Technical Service Bulletin: tsb100701

Released Date: 23-May-2008

New Connecting Rod

Old Connecting Rod Bushing (left) and New Connecting Rod Bushing (right)

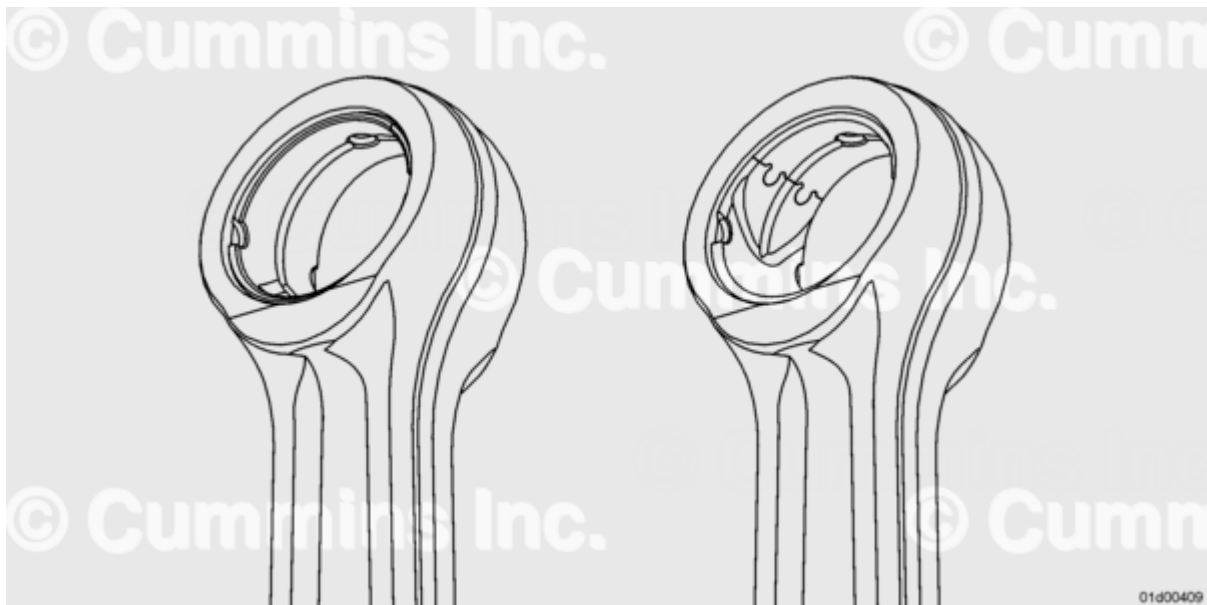
This Technical Service Bulletin announces the release of a new connecting rod to be used on all 8.3 liter engines.

The new connecting rod has a newly designed bushing oil groove. Connecting rods with the old and new style bushings can be mixed within the same engine.

The table below identifies the part number and engine serial number (ESN) first for the old and new connecting rods.
